AGENDA

Lexington Planning Board

Thursday, January 30, 2025

**Re: Site Plan Review for 185 & 187-189 Bedford Street; Village and Multi-Family Overlay District;
Staff Memo #2**

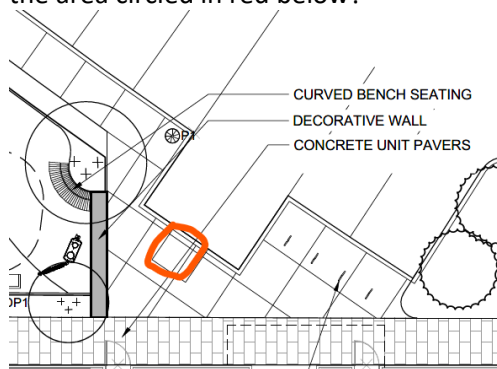
- No loading bay required for the proposed use/square footage (5.1.5), however the Applicant proposes a loading zone near the playground, presumably for resident move-in/out and waste removal services. Provide signage and label this area as a loading zone on the planset. What is the area circled in red below?

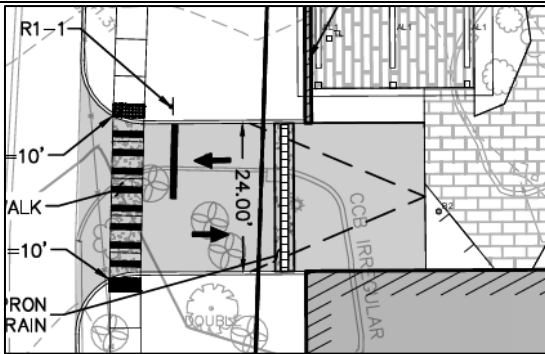
The garage entrance driveway is within 5-feet of the building wall. The width of this 2-way entrance is 24 feet and only 18 feet is required (5.1.13.1.d). The plans show pavement up to the building wall, however the drive aisle width does not need to be considered that close.

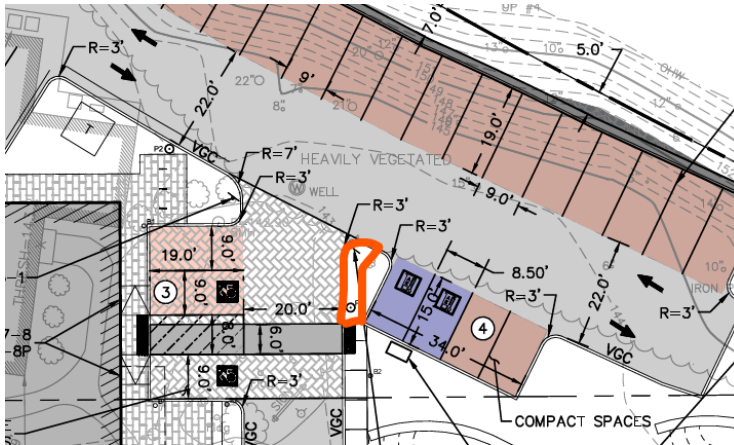
- “Structures and canopies should be designed for solar and other energy systems”. Applicant shows potential areas for solar on the building’s rooftop.
